5531

BOARD OF ZONING ADJUSTMENT

ANALYSIS APPLICATION 5531

Date: August 3, 2009

SITE PLAN

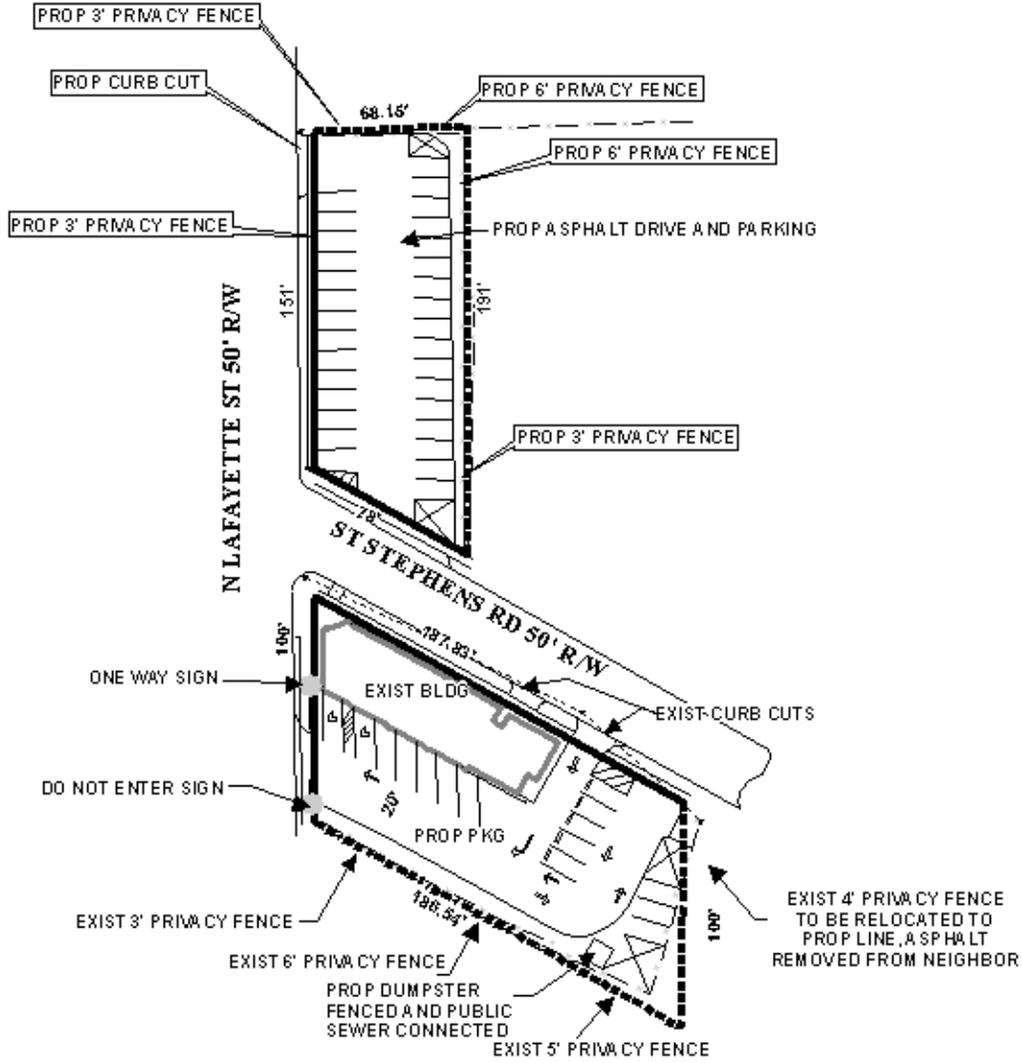
Traffic Engineering has reviewed the site plan and has determined that it is dysfunctional for the following reasons:

Lot 1

- 1) the driveways are not clearly shown;*
- 2) the narrow driveway should be signed "one-way" and/or "do not enter";*
- 3) the driveway radii appear to be less than 20';*
- 4) there is insufficient room for the northern-most parking stall to back out;*
- 5) the 20' wide aisle is too narrow (two-way traffic requires a 24' width).*

Lot 2

- 1) radii dimensions are not indicated;*
- 2) the asymmetrical stalls must be striped out since they will not accommodate cars;*
- 3) it is unclear if there is to be a drive on the South side, and if so, it should be indicated;*
- 4) the existing Southern most drive on the South side cannot function.*

As some of the items would require minor site plan revisions and clarifications, others are truly problematic. Two-way drive aisles must be 24' wide, for instance. Also, parts of the parking area and buffer fence on Lot 1 encroach onto the property to the East of the site. An on-site review of the site also revealed the dumpster against that fence, but there is no provision on the site plan for the dumpster and adequate vehicular access.

A revised site plan was submitted addressing most of the issues. Some curb cut issues could not be corrected due to the location of utility poles in the right-of-way. Further Traffic Engineering concerns beyond those cited in the holdover reasons were coordinated with that department and incorporated into the site plan. And the site plan now includes a properly located dumpster and enclosure, and elimination of the privacy fence and paving encroachments onto the neighboring property along St. Stephens Road.

spaces, has always been unstriped. The unpermitted rear expansion of the building further increased the previous deficit and increased the parking requirement to 34 spaces. The substandard parking ratio could be considered as a hardship condition imposed by the property, and the off-site expansion of the parking area with compliant paving, striping and traffic control measures would eliminate this condition. However, buffer fencing variance requests should not be considered for approval as no hardship is indicated to justify granting of such. Buffer fencing should be of the required 6' height along adjacent residentially zoned or used properties, dropping to 3' high within 25' of respective street rights-of-way. There do not appear to be any site constraints which would prevent the construction of 3' high wooden privacy fences along the street frontages of the parking lots where there are residentially zoned properties directly across from those street frontages. The site plan indicates some areas where minimal amounts of landscaping and tree plantings may possibly be provided, but these are insufficient to comply with the minimum requirements.

Based on the preceding, the requests for use and off-site parking in R-1 and B-2 zoning districts are recommended for approval, subject to the following conditions:

- 1) modification of the recently-added parking areas to match the revised site plan of June 19, 2009, and to provide landscaping and tree plantings in compliance with numbers and ratios required for commercial development, to be coordinated with Urban Forestry;*
- 2) all directional arrows applied to paving to be Thermoplastic as approved by Traffic Engineering;*
- 3) installation of parking lot lighting in compliance with Section 64-6.A.3.c. of the Zoning Ordinance, specifically so arranged that the source of light does not shine directly into adjacent residential properties or into traffic; and*
- 4) obtaining of any “after-the fact” permits normally required for improvements already made, and obtaining of any permits required for further improvements.*

The requests for buffer fencing and buffer fence height variances are recommended for denial.
